DeKalb County Historic Preservation Commission

Staff Report

A. 1467 Oxford Road, Tse Chih Chang. Replace window. **1247320.**

1467 Oxford Rd Front Window Replacement

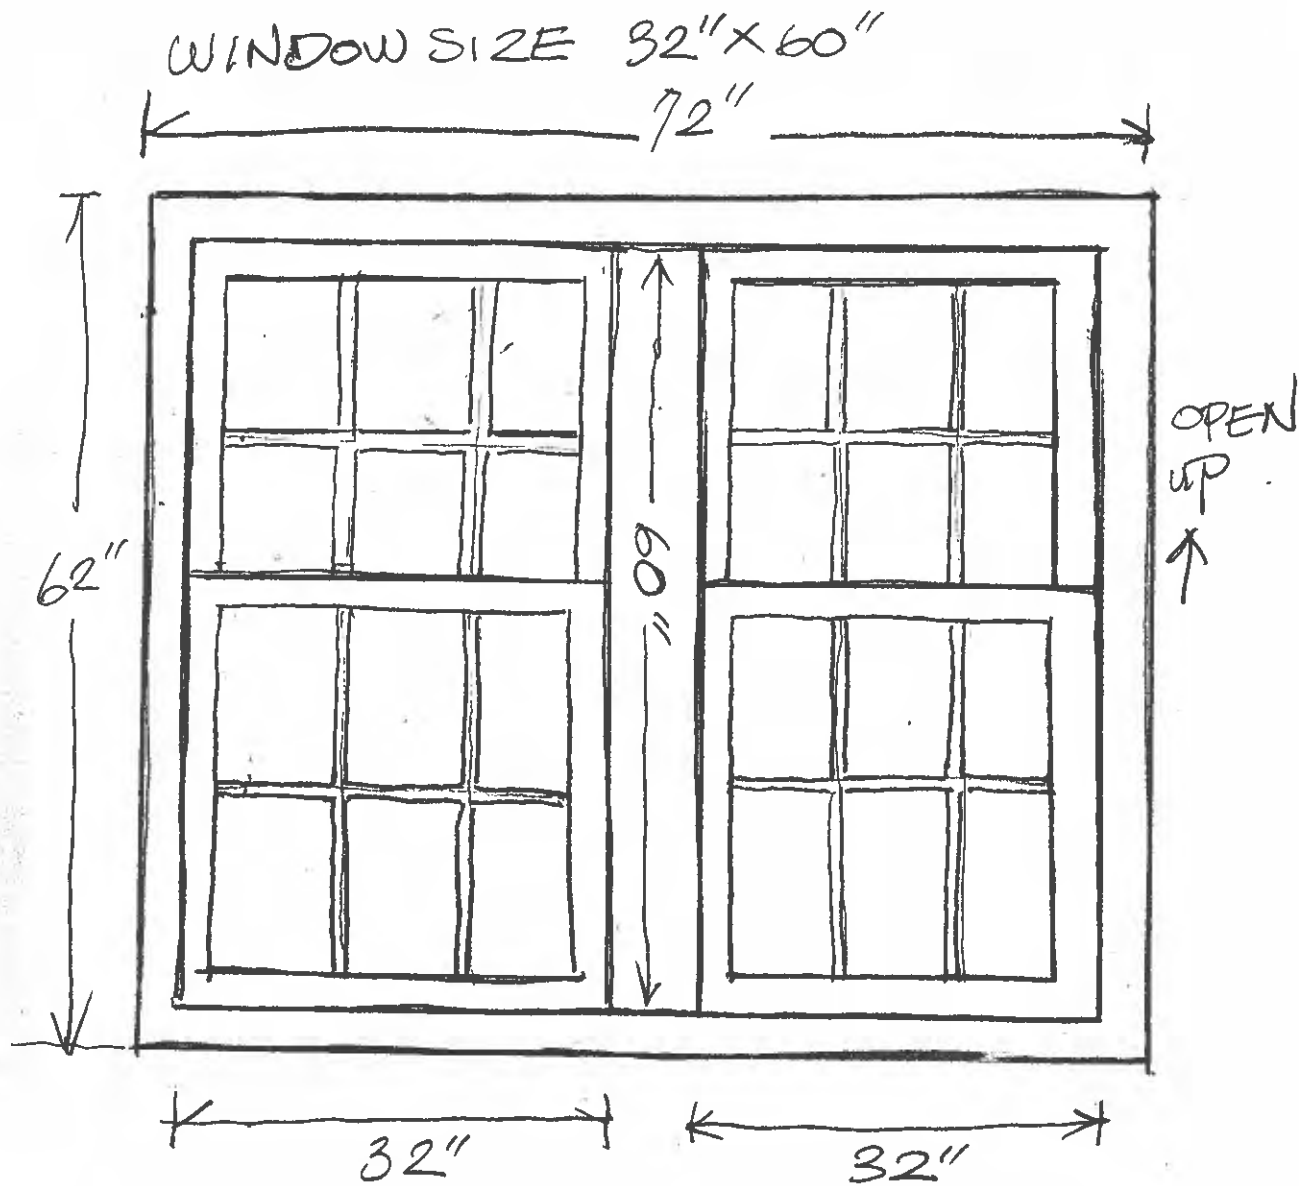
The applicant proposes replacing front windows. The original windows were damaged, and the replacement windows match the dimensions of the original windows. The replacement windows are wood double-hung windows to match the original windows as well. The replacement windows have simulated divided lites that were not present on the original windows, which were single pane windows with no divided lites. This work has been completed, and this is a retroactive application.

replace broken front windows which were damaged by street bullets

Approve. These proposed changes do not appear to have a substantial adverse effect on the district. This application appears to meet the guidelines and the staff recommends approval.
